HISTORIC AND DESIGN REVIEW COMMISSION

Agenda Item No: 13

HDRC CASE NO: 2015-109
ADDRESS: 1115 S ST MARYS
LEGAL DESCRIPTION: NCB 2963 BLK 11 LOT S 95 FT OF A19
ZONING: C2 H HS
CITY COUNCIL DIST.: 1
DISTRICT: King William Historic District
APPLICANT: Arturo Rivera
OWNER: Roberto Medrano
TYPE OF WORK: Construction of a semi-circular driveway and fence replacement
REQUEST:

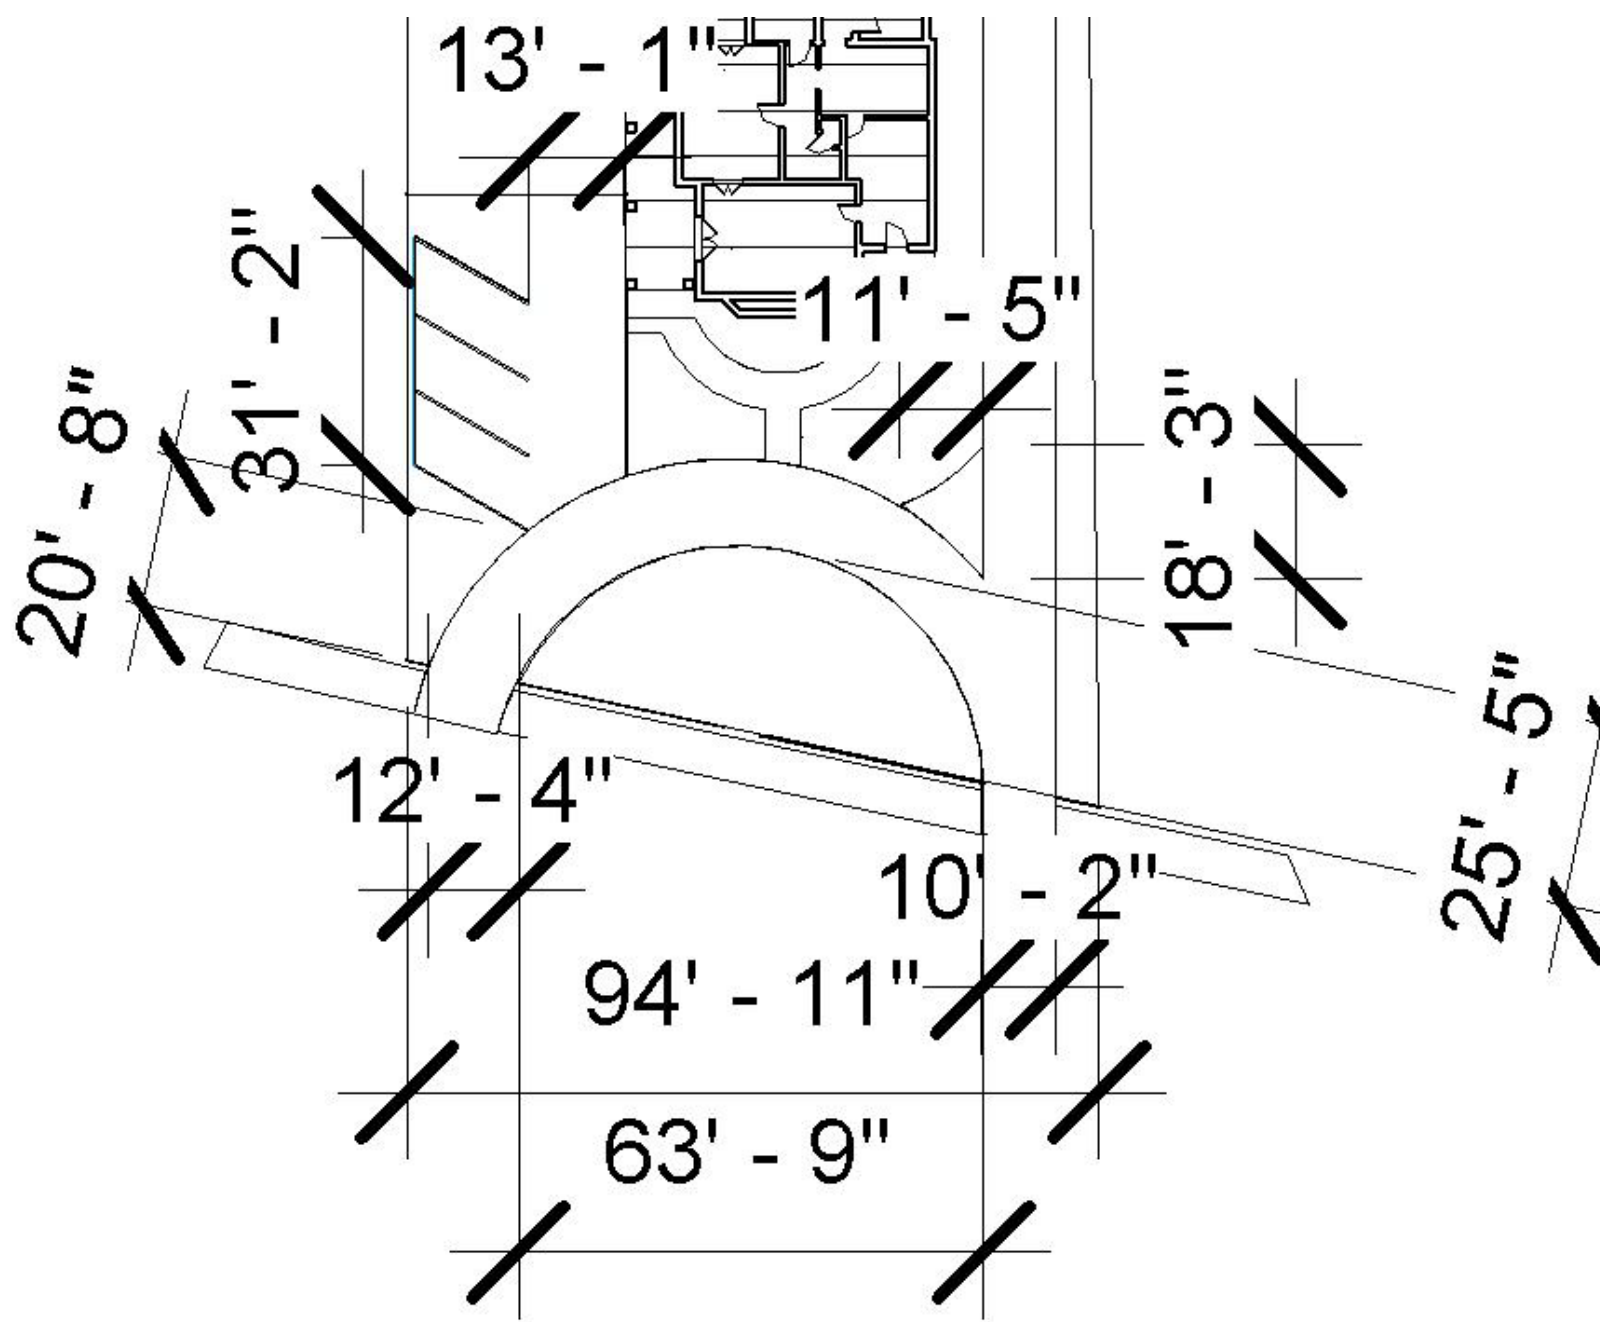
- b. The applicant has proposed to install a circular drive and three additional parking spots that will be on the southern side of the front yard. The applicant will use the exiting curb cut on the north side of the site and will add one (1) new curb cut on the south side of the site for exiting vehicles. The existing curb cut is approximately ten (10) feet in width. The applicant has proposed for the new curb cut and driveway to be approximately twelve (12) feet in width. Circular driveways are not typically found in historic districts, are not consistent with the Guidelines for Site Elements and disrupt the existing front of lot pattern found along S St Mary's at other historic structures. Staff Does not recommend approval of the circular driveway. The new driveway should be straight and should be ten (10) feet wide.

- d. Along the front (east) of the property at the side walk and along the drive way on the north side, there is an existing wrought iron fence. The applicant has proposed to remove the wrought iron fence from the front of the property at the side walk and replace it with a white, wood picket fence. The Guidelines for Site Elements 2.A.ii. states that only deteriorated sections of fences that are beyond repair should be replaced. If the existing wrought iron fence along the front of the property were replaced, the applicant would have the new, wood picket fence in the front and the existing wrought iron fence on the side along the existing driveway. Staff recommends that the applicant modify the existing wrought iron fence to accommodate the proposed semi-circular drive.

Staff does not recommend approval of item #2 based on finding b. Staff recommends that the applicant install a straight driveway to be ten (10) feet wide.

Staff does not recommend approval of item #3 based on finding d. Staff recommends that the applicant have one continuous fencing material on the site.
